Job No: IAC-446

**HEALTH INFRASTRUCTURE
LEVEL 6, 77 PACIFIC HIGHWAY
NORTH SYDNEY NSW 2060**REFERENCE: NSW FORENSIC PATHOLOGY AND CORONERS COURT
DOCUMENTATION REVIEW
ATTENTION: MR AARON SMITH

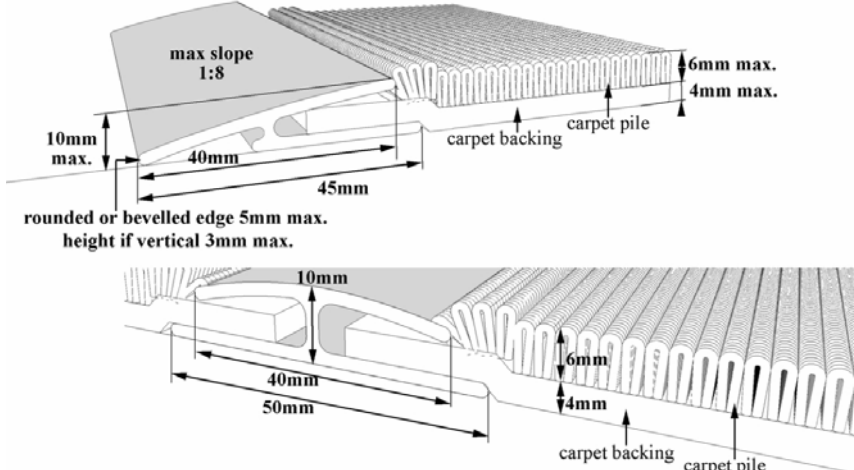
20.	SD-006	Stair 1	<p>The detailing of Stair 1 will need to satisfy the provisions of Clauses 11 & 12 of AS1428.1:2009.</p> <p>The lighting level on the stair will need to satisfy Clause 19 of AS1428.2:1992 (150 lx)</p>	<p>Noted. Item to be developed under design development.</p>

21.	SD-006	Stair 2	<p>The detailing of Stair 2 will need to satisfy the provisions of Clauses 11 & 12 of AS1428.1:2009.</p> <p>The lighting level on the stair will need to satisfy Clause 19 of AS1428.2:1992 (150 lx)</p>	<p>Noted. Item to be developed under design development.</p>

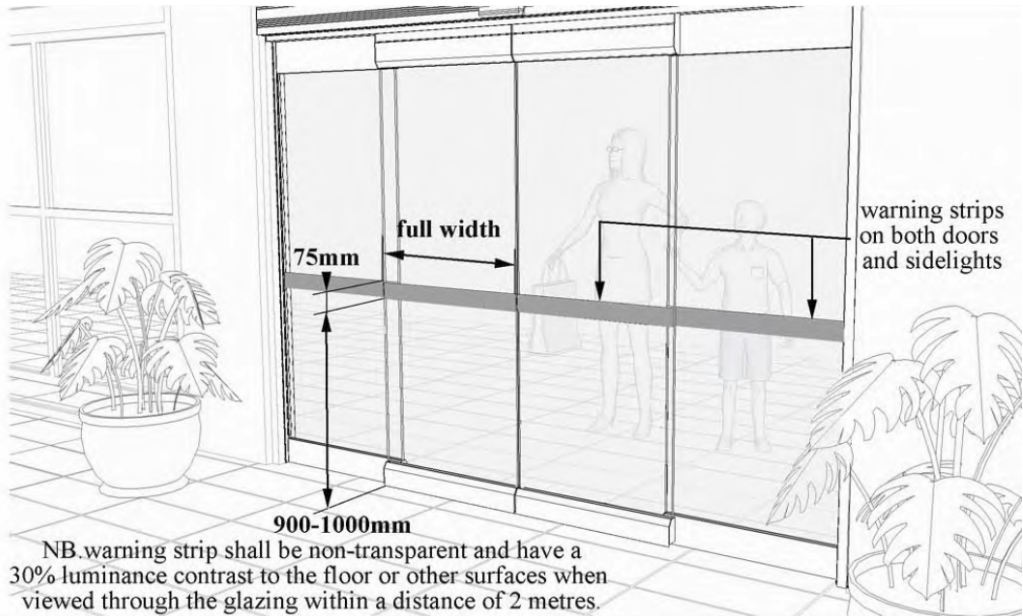
36.	SD-006	Doors Generally	All doors to accessible rooms will need to have a minimum clear width of 850mm and will need to satisfy the provisions of Clause 13 of AS1428.1:2990. Where double doors are installed the minimum clear width of the active leaf will need to be 850mm. The force required to operate doors (other than fire doors) fitted with door closers will need to be 20N The placement of vision panels in doors will need to satisfy the provisions of Clause 11.6.2 of AS1428.2:1992 (refer to attached Technical Sheet)	Doors are show at 970mm. Other items to be developed under design development.

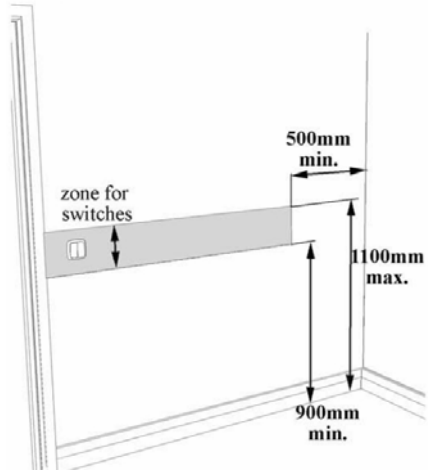
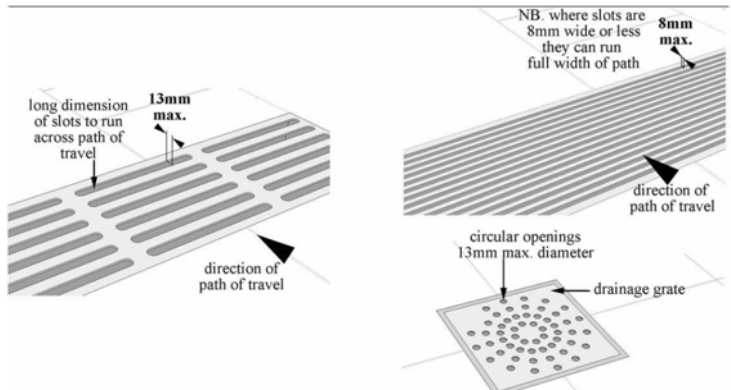
Documentation Review				
No	DWG No	Room	Discussion	Action
42.			 <p>Architectural drawings for item 42. The 'TOP VIEW' shows a row of seats with a width of 1760 min and an 'Entrance' area. The 'PLAN - APPROACH FROM THE FRONT' shows a side view of the seating area with dimensions: 330 min, 1700, 800, 2450 min, 1200 min, and an 'Aisle 1000 min.' with a 'Step or top of sloped aisle'.</p>	Noted. Item to be developed under design development.
43.	SD-008	Waiting	The detailing of the furniture in the waiting areas will need to satisfy the requirements of Clause 27 of AS1428.2:1992	Noted. Item to be developed under design development.
44.	SD-008	Ramps	There is no information as to the gradient of the ramps to the coroner's courts. The detailing of the ramps will need to satisfy the requirements of Clause 10 of AS1428.1:2009.	Noted. Item to be developed under design development.
